# CITY PLANNING COMMISSION

- APPLICATION:**
- A. Tentative Map to divide 0.7 $\pm$  vacant acres into three lots in the Flood (F) zone.
  - B. Special Permit to develop a six-unit, 6,048 $\pm$  sq. ft. airspace condominium development.
  - C. Subdivision Modification to waive standard street improvements.

**APPLC. NO.** P87-359 **MEETING DATE** 9/24/87 **ITEM NO** 16

EXHIBIT A

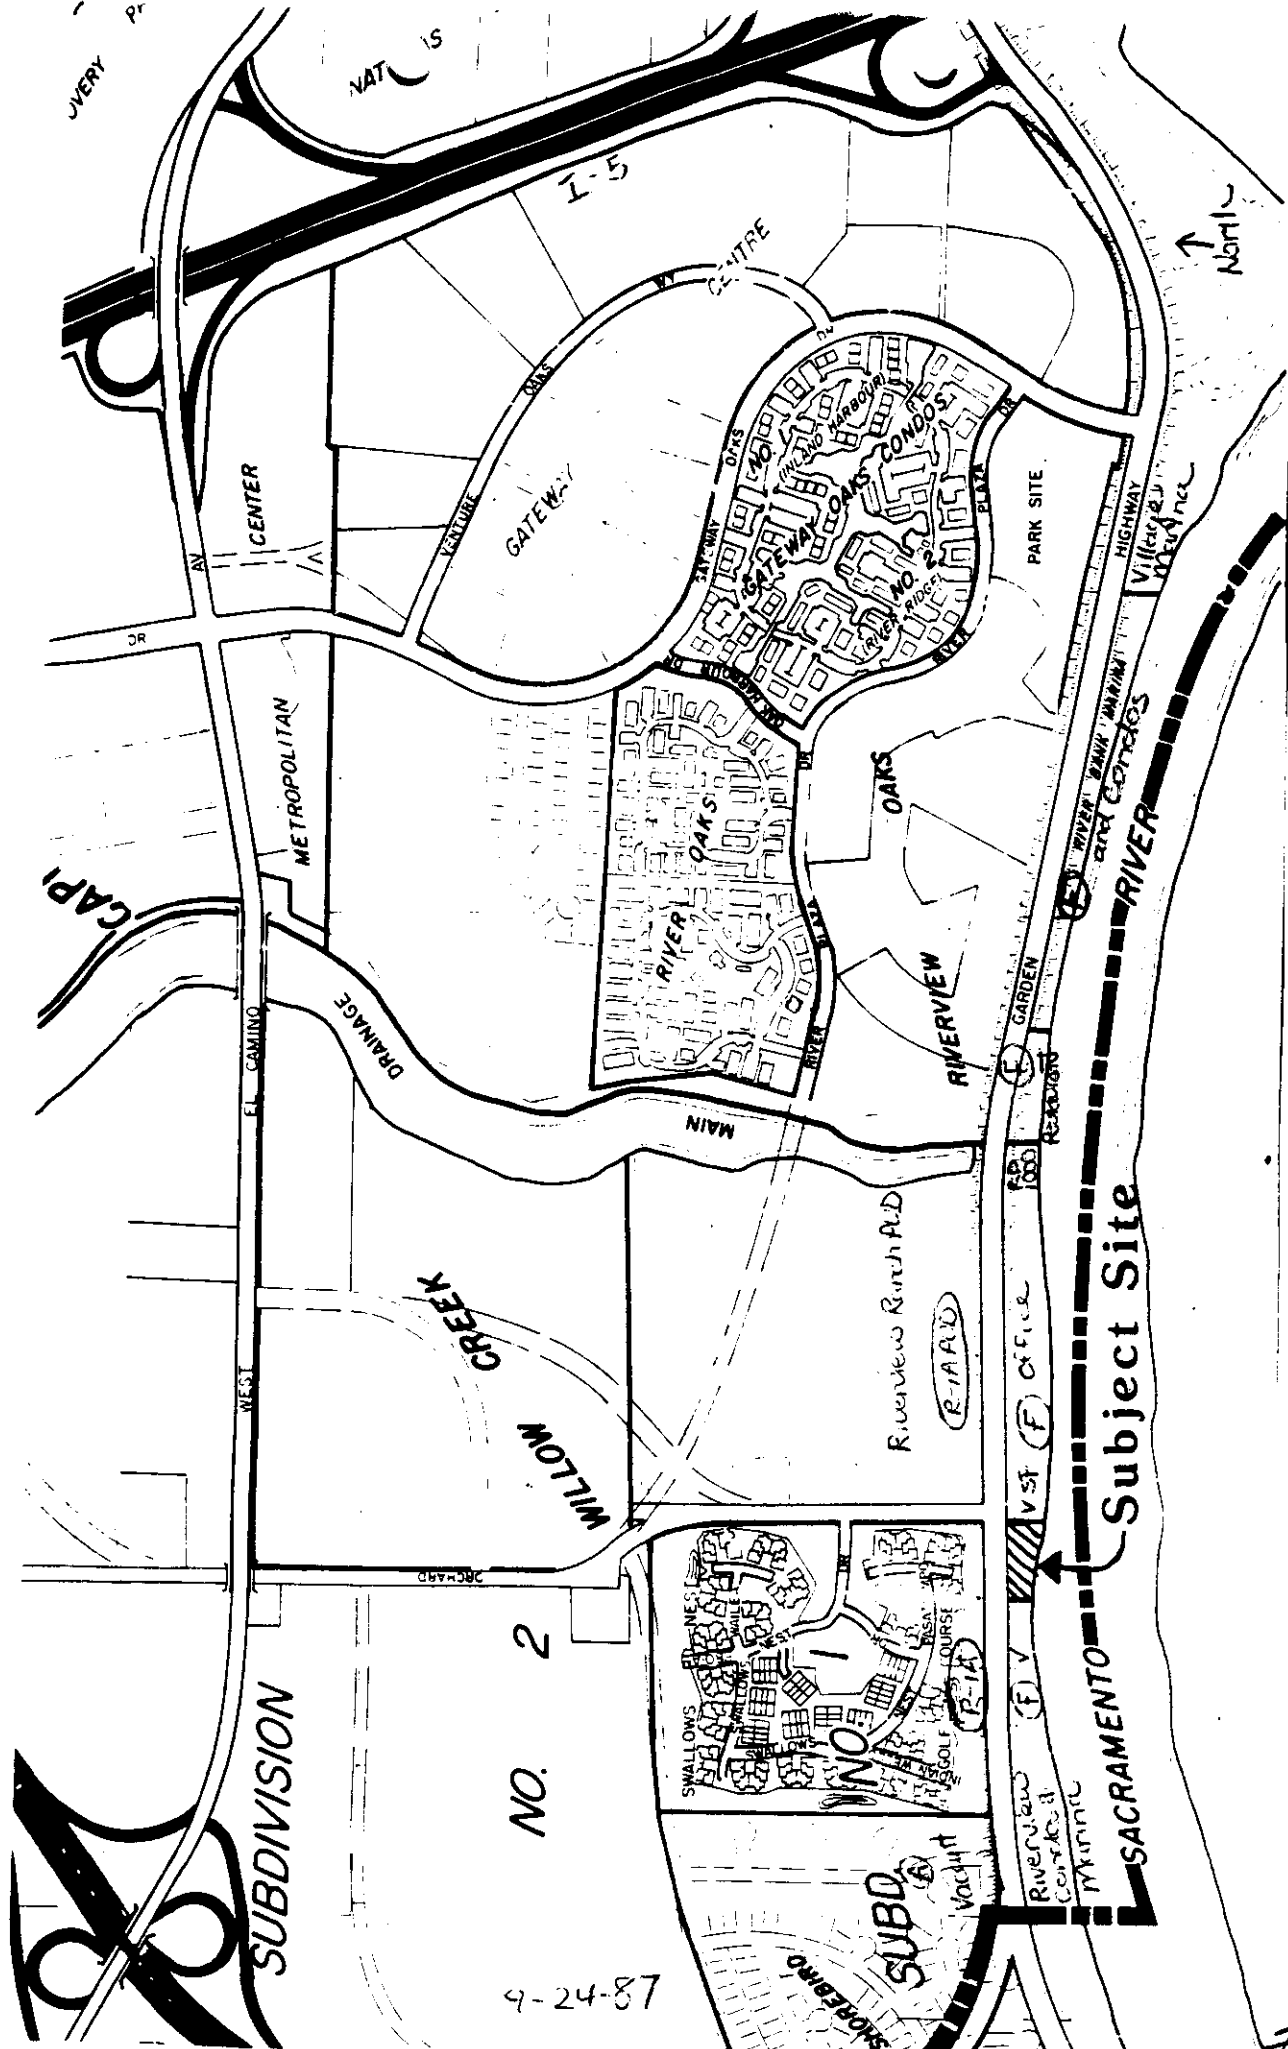
Residential developments are allowed in the Riverfront District and in the Flood zone with special permit approval. Planning staff finds the project to be an appropriate land use for the site if the tentative map is revised to show a one lot subdivision. Presently Lot C provides the only usable open space area for the project and provides the public view of the Sacramento River from the Garden Highway as required by the Riverfront District designation. The proposed density of the project is 8.5 dwelling units per acre when the acreage of the entire site (0.7± acres) is used. This density is compatible with the densities of the two adjacent condominium developments, Riverbank Holding Company and Riverview Marina. If the Lot C acreage is removed from the calculations and allowed to develop separately the density of the condominium development would increase to 12 dwelling units per acre. Planning staff finds that six units on 0.5± acres with little usable open space would be too intense of a project for the site. The applicant has indicated that he is willing to revise the map to indicate a one lot subdivision as recommended by Planning staff.

1. The map shall be revised to show a one lot subdivision;
2. Provide street lights pursuant to Section 40.811 of the City Code;
3. Prepare a sewer and drainage study for the review and approval of the City Engineer; may require off-site extensions and oversizing;

**EXHIBIT B**

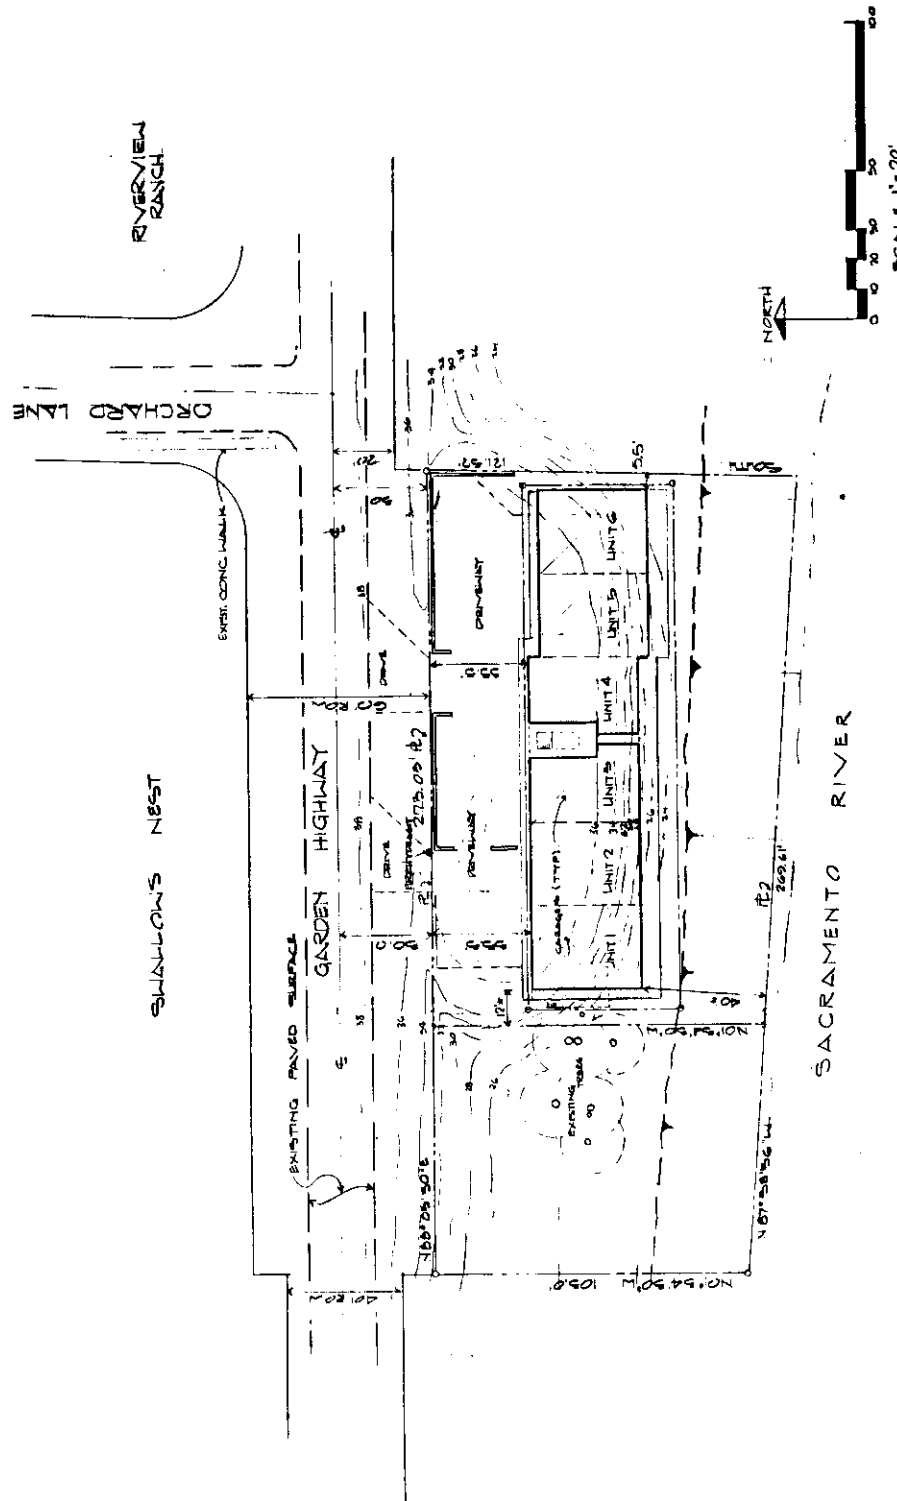
The applicant's site plan indicates the retention of the existing oak trees on the eastern portion of the site (Exhibit B). No other landscaping has been indicated. Planning staff recommends that a revised landscape and irrigation plan be submitted for Planning Director review and approval. The landscape plan should include: 1) the retention of all natural vegetation and inclusion of new vegetation as required by interested State and Federal Agencies; 2) a minimum four foot wide planter between the public right-of-way and any paved areas; and 3) a landscape plan for the western portion of the site which provides a usable open space area for the condominium residents.

Driveway entrances for the project as shown on the submitted site plan are inadequate. Two-way driveways must be a minimum of 24 feet wide. If driveways are proposed to be one-way only, the circulation plan must receive the approval of the City Traffic Engineer. The two proposed driveways for the project will need to be revised to the satisfaction of the Traffic Engineering Division prior to issuance of building permits.

A solid wall is indicated on the site plan adjacent to the public right-of-way. Any fencing in this area must meet the approval of the State Reclamation Board. Any fencing must also meet the visibility requirements of the Zoning Ordinance and Traffic Engineering Division. The Fire Department has indicated that they will not permit any obstacles in the driveway area adjacent to the condominium structures. The proposed fence in this area will need to be removed.

- b. retention of the existing Oak Grove;
  - c. a minimum four foot wide planter between the public right-of-way and any paved areas; and
  - d. a landscape plan for the western portion of the site which provides a usable open space area for condominium residents.

4. Construction work and placement of impervious surfaces shall be approved by the City Arborist.
5. The applicant shall submit the detailed plans which indicate the driveway locations for the review and approval of the City Traffic Engineer prior to issuance of building permits.

6. The design and materials of the fence proposed adjacent to the Garden Highway right-of-way shall be subject to the review and approval of the Planning Director prior to issuance of building permits. The proposed fence shall also meet the requirements of the State Reclamation Board, City Fire Department, and the visibility requirements of the Zoning Ordinance and Traffic Engineering Division.

# EXHIBIT D

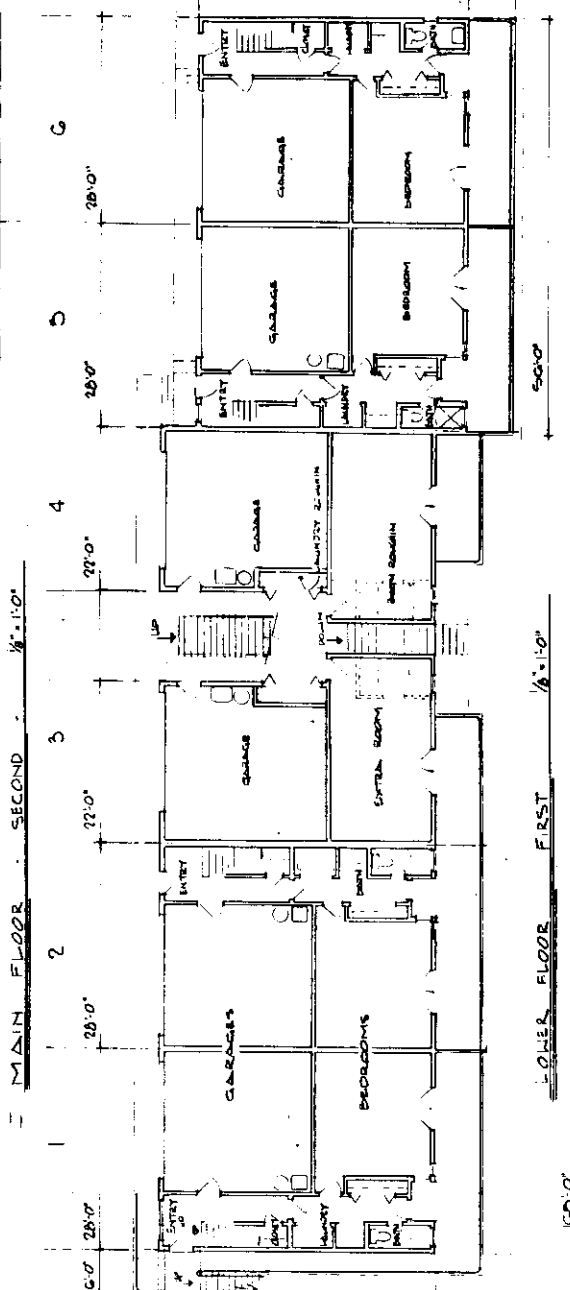
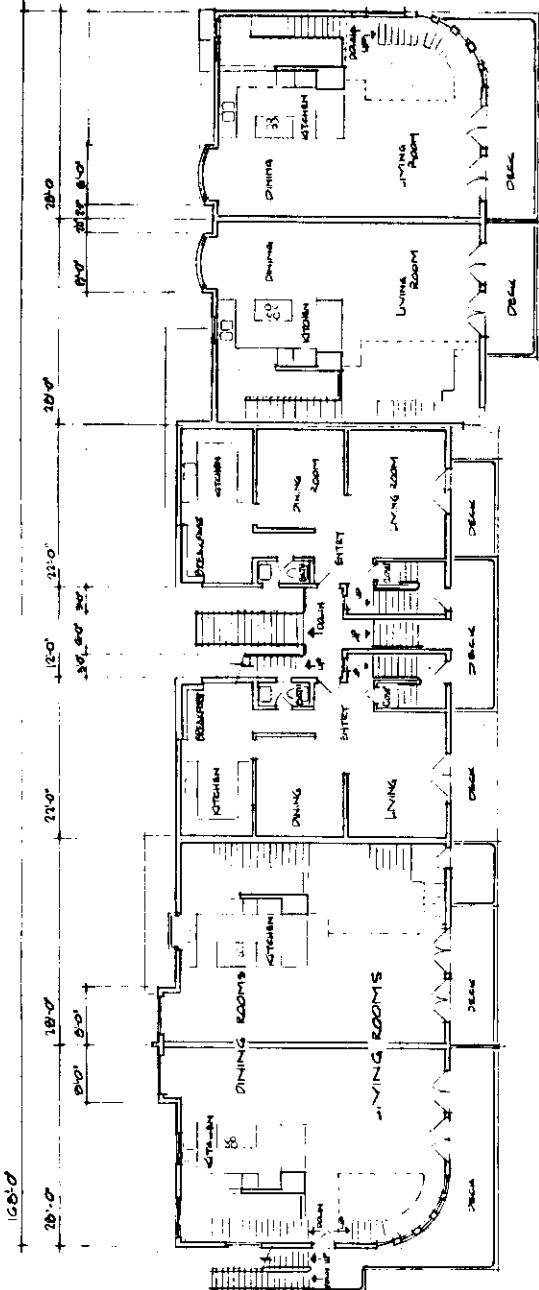
The applicant has met with Planning staff several times to discuss the proposed building elevations. The proposed units are three (Exhibits C-E) stories, 29 feet high measured from the Garden Highway side of the structure to the top of the plate line. Two of the units have three bedrooms, the remaining four units have two bedrooms. Each level of each unit has an outdoor balcony facing the river. Each unit also has a two car garage. Proposed building materials are wood shiplap siding and a metal roof. In order to avoid one long building facade, the applicant has off-set units 5 and 6 from the rest of the four units and provided different roof pitches.

Planning staff finds that the applicant has made substantial progress in designing a residential project that is compatible with the theme of the Riverfront District. Some more detailing, however, is needed on the elevations. Staff recommends that revised plans and elevations be submitted for the review of the City Design Review staff prior to issuance of building permits.

7. Revised elevations for the project shall be submitted for the review and approval of City Design Review staff prior to issuance of building permits.
